ATtiny1614/1616/1617

Silicon Errata and Data Sheet Clarifications

Figure 3-1. Block Diagram

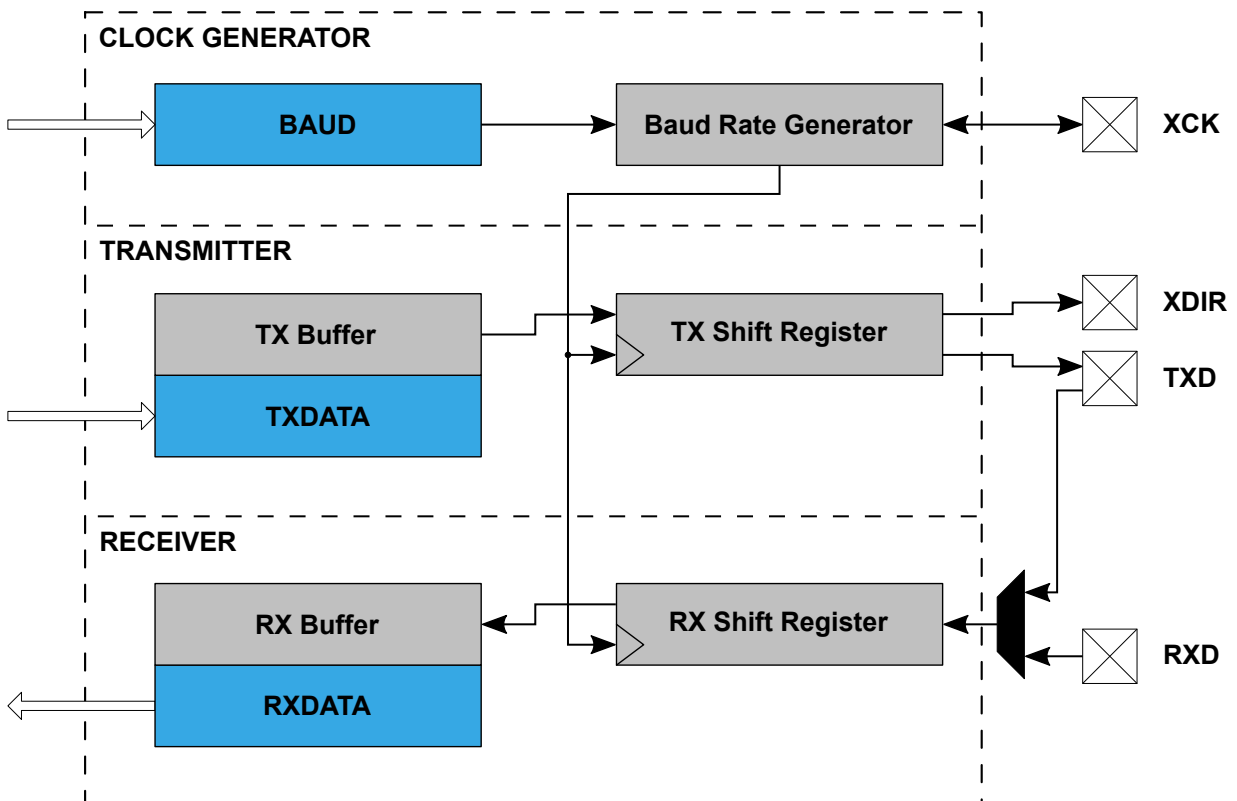
The block diagram is missing that USART TX is double-buffered from Figure 25-1 in the data sheet. The figure below shows the added **TX Buffer**.

The following text is changed in the *Overview* section:

The transmitter consists of a **two-level** write buffer.

The following text is changed in the *Data Transmission* section:

The data transmission is initiated by loading the **Transmit Data (USARTn.TXDATAL and USARTn.TXDATAH)** registers with the data to be sent. The data in the **Transmit Data registers are moved to the TX Buffer** once emptied and then to the Shift register once it is empty and ready to send a new frame.
